Manchester, King Street

Planning update

Planning Permission and Listed Building Consent were received (with conditions) on 7th January 2022 for the proposed scheme.

Updates to the design that are required to meet current regulations and standards, and to future-proof the sustainability of the scheme are as listed below.

Amended Roof Plan Proposals

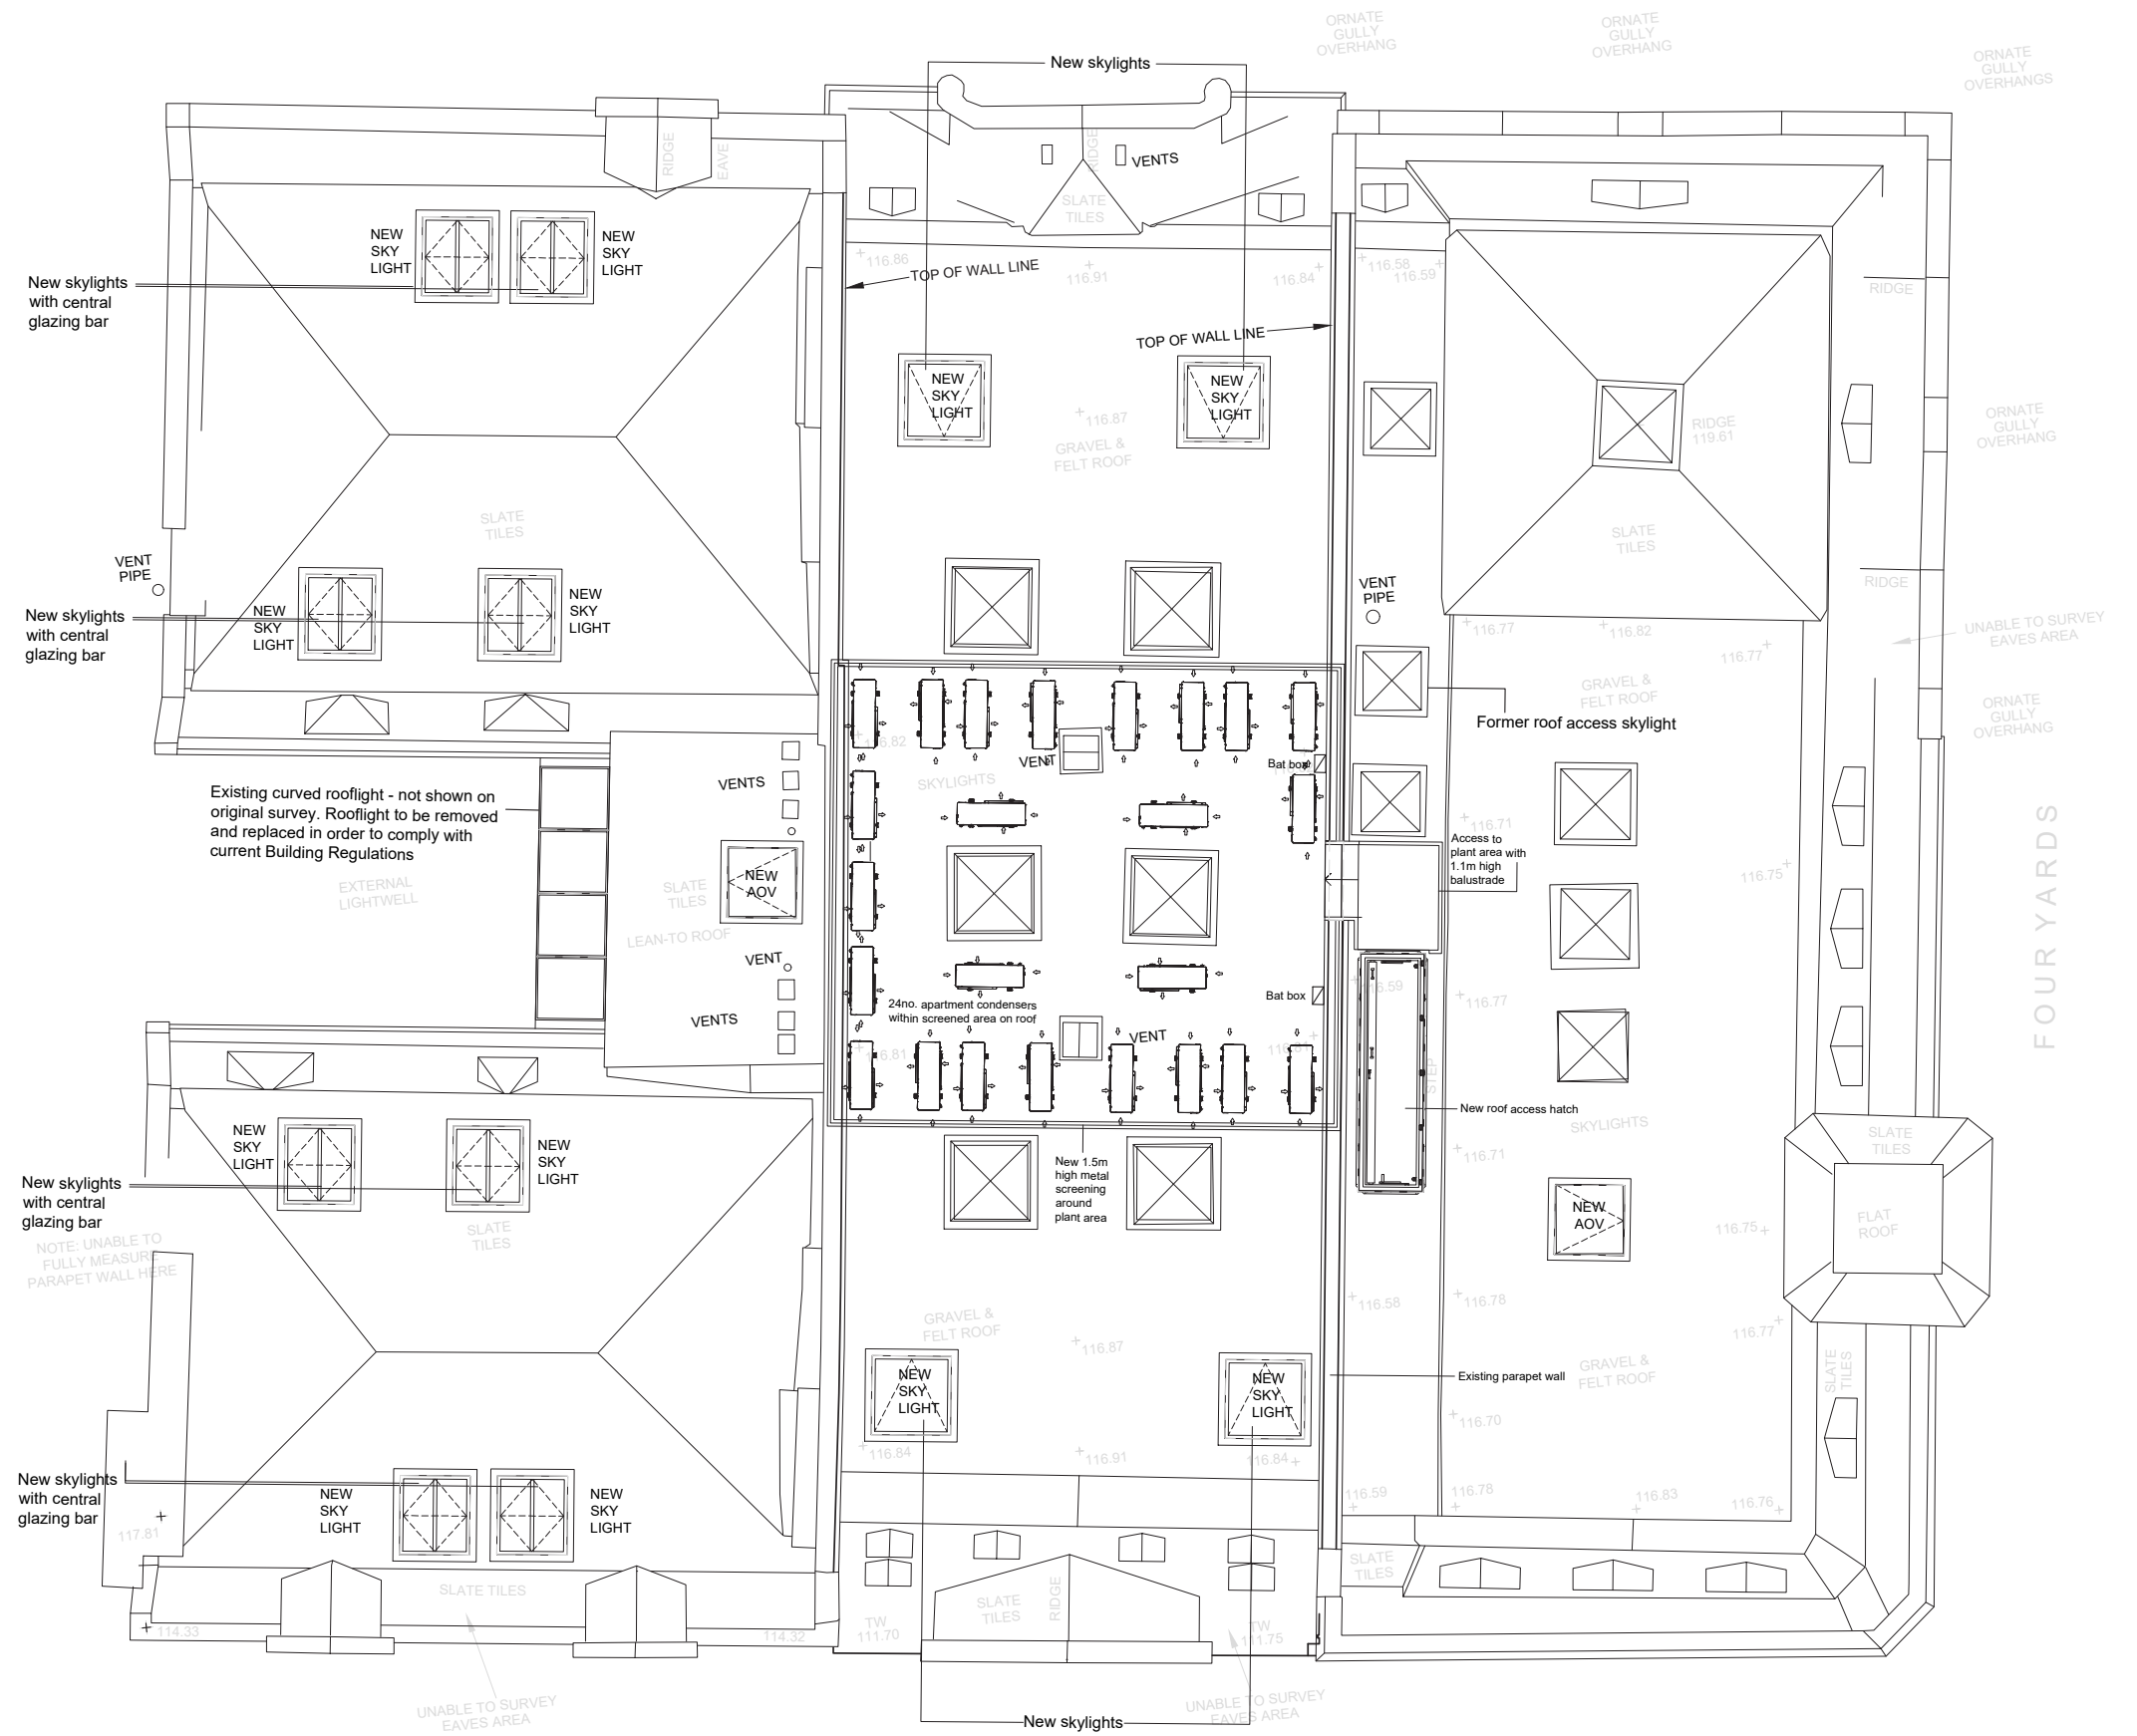
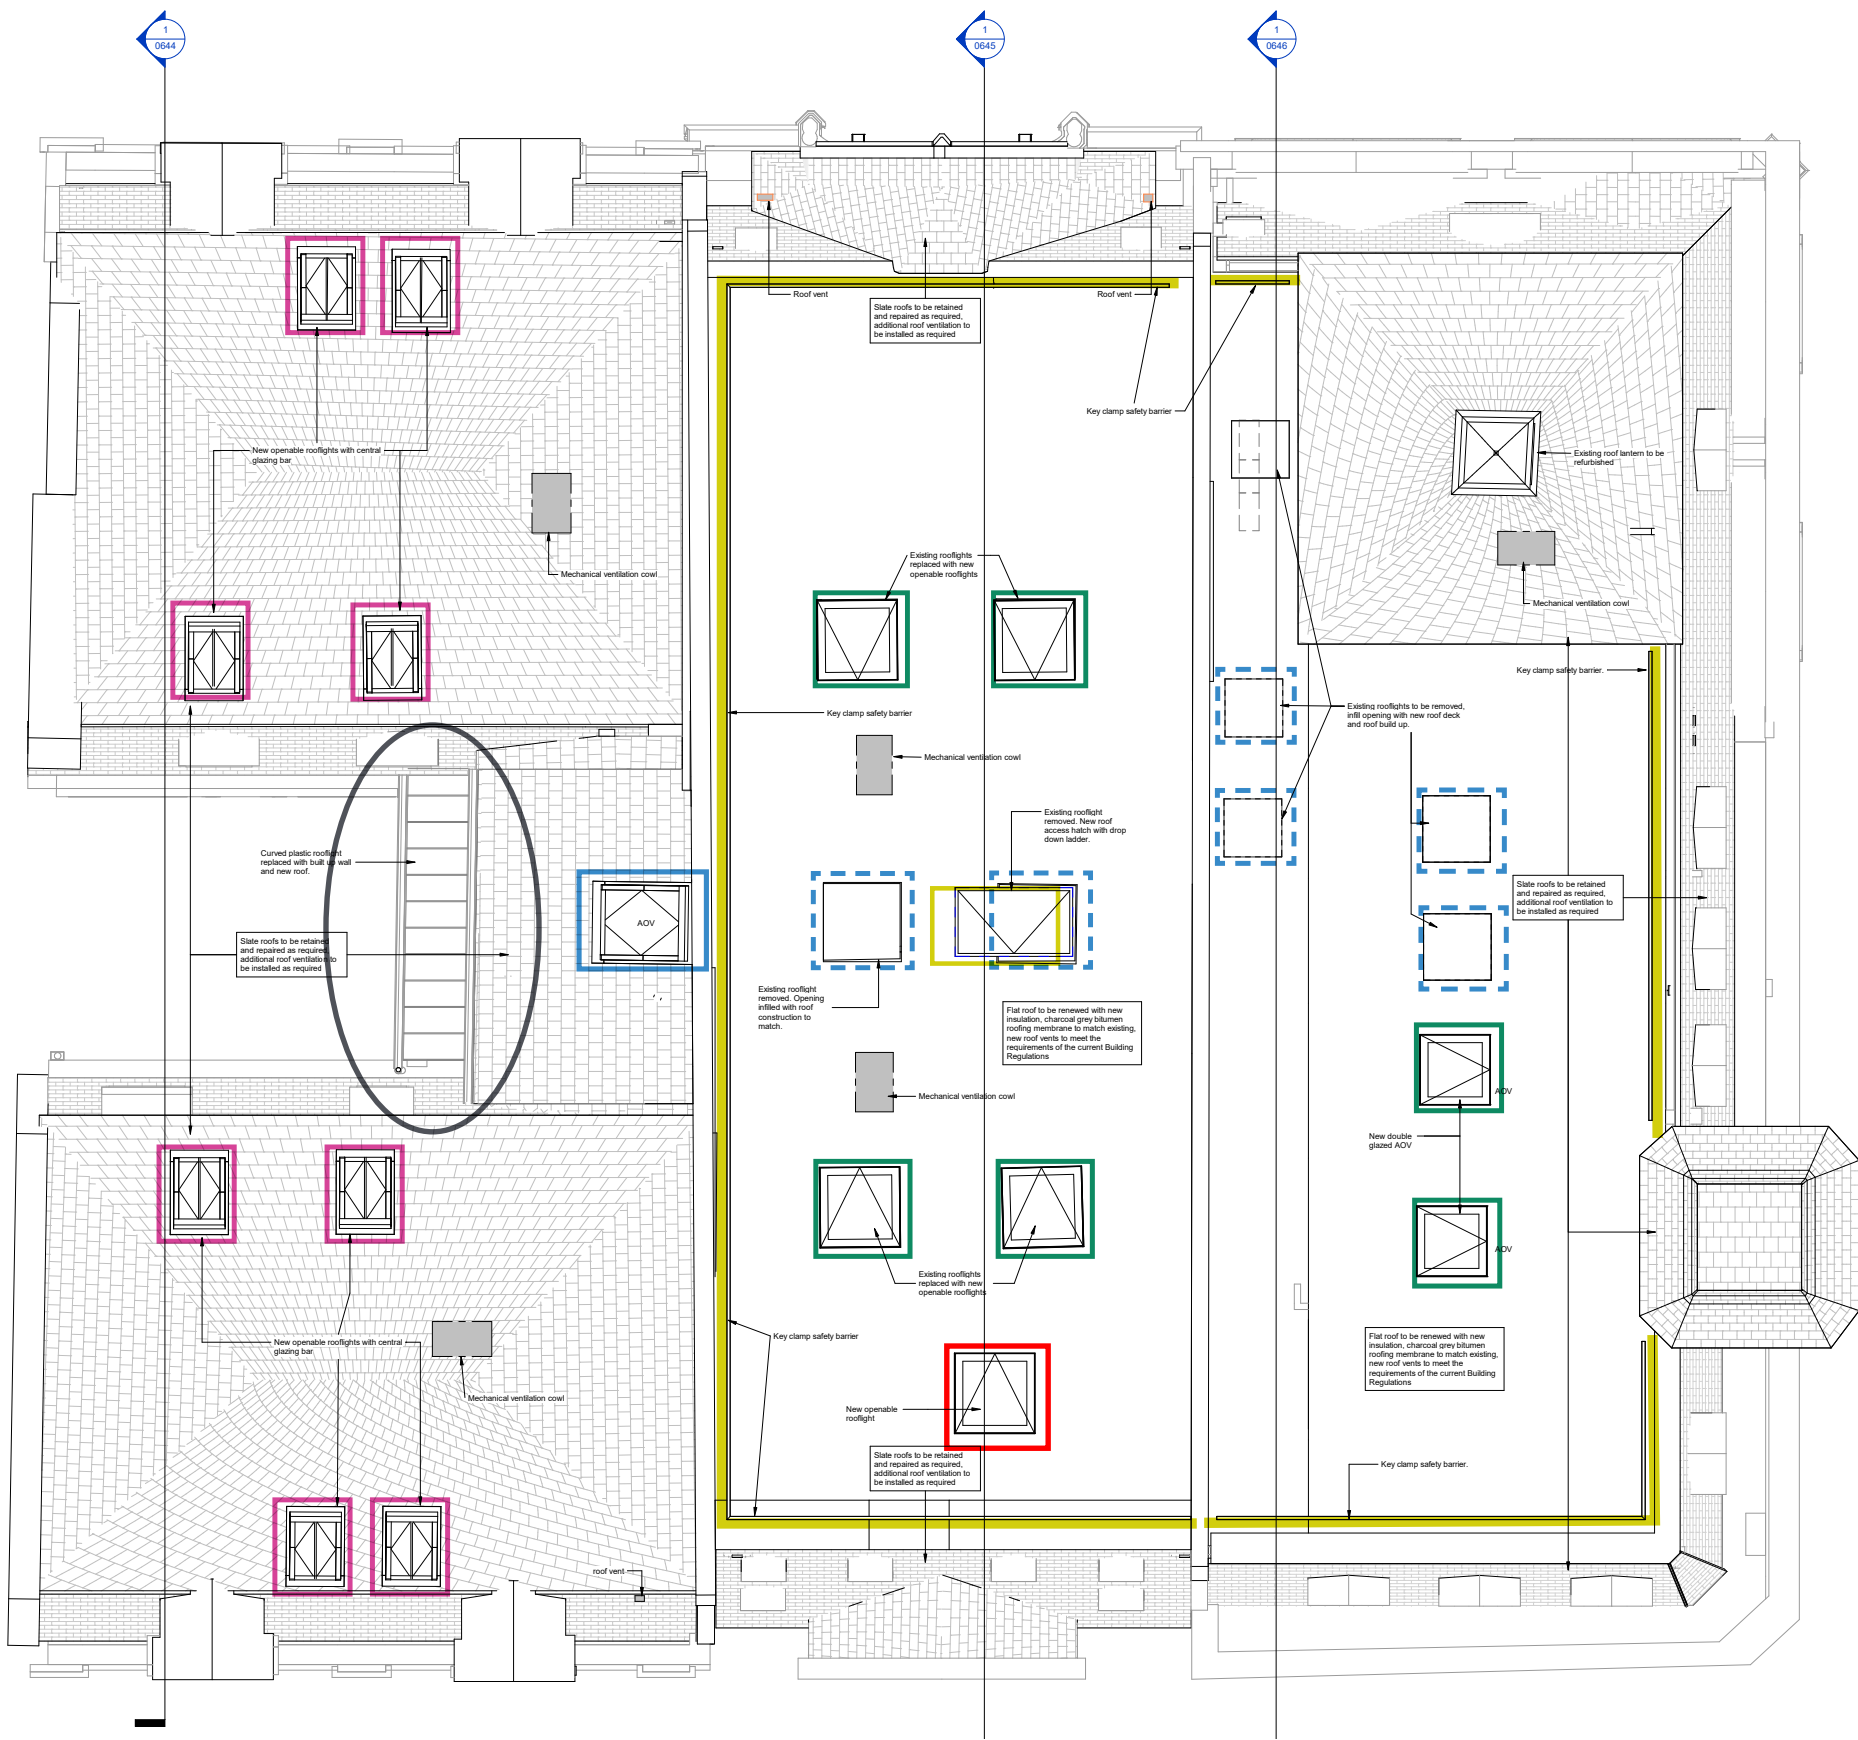
- Roof Plant deck omitted
- Flat roof covering replacement, including works to parapet copings
- Remediation works to slate roof and gutters (including leadwork)
- Roof perimeter protection added
- Changes to rooflights

- Existing rooflights to be removed
- Existing pyramid rooflight to be replaced with new flat/plane rooflight and AOV
- New flat rooflights
- New pitched roof conservation style rooflight
- New pitched roof AOV
- New roof access hatch for maintenance
- Roof perimeter guardrail
- Existing curved rooflight replaced

AMENDED PROPOSED ELEVATION B

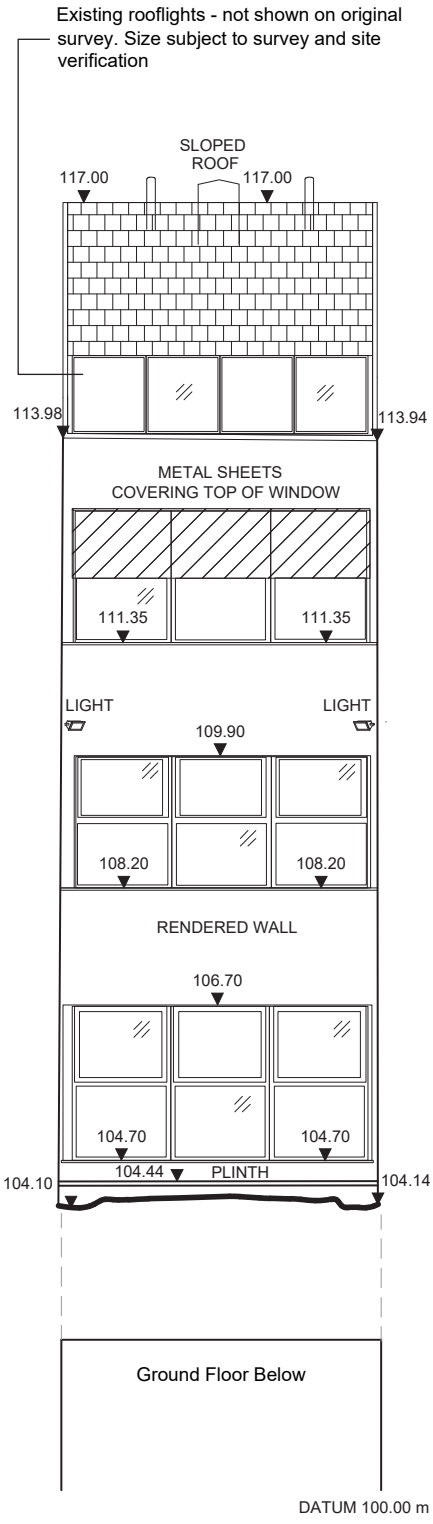
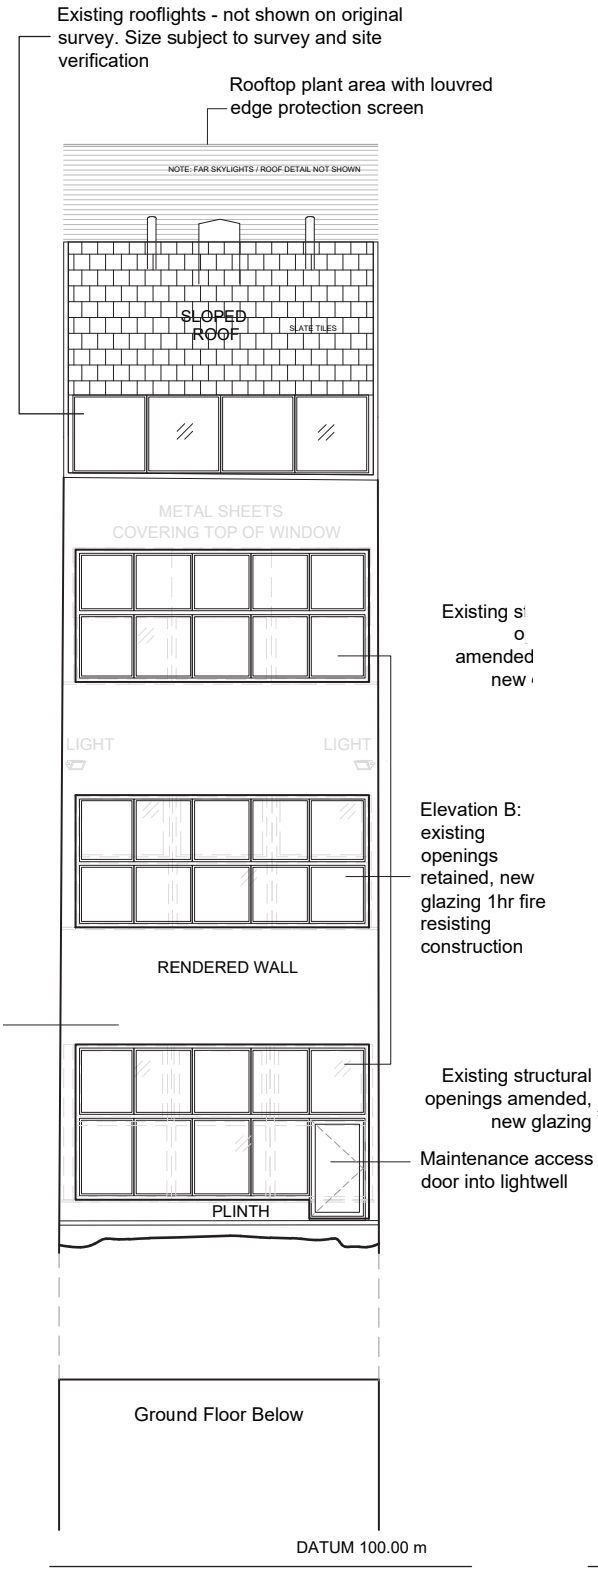
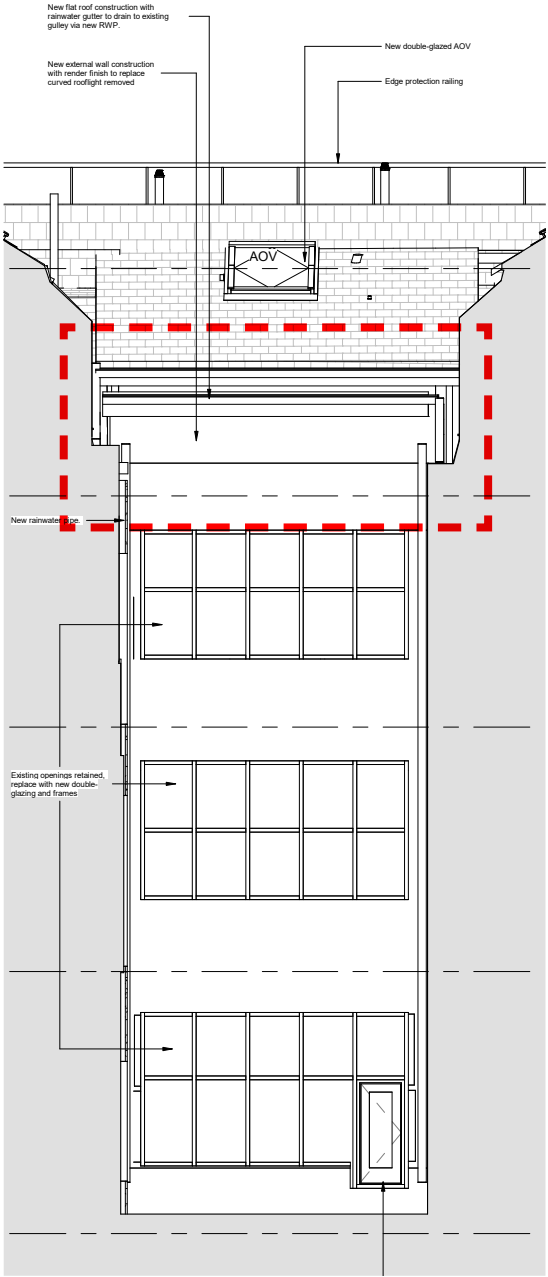
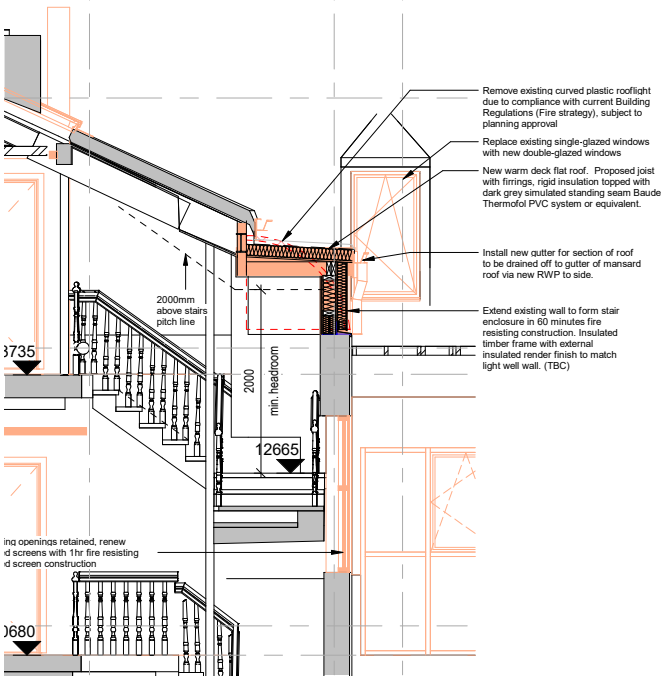
Existing curved rooflight replaced with flat roof construction
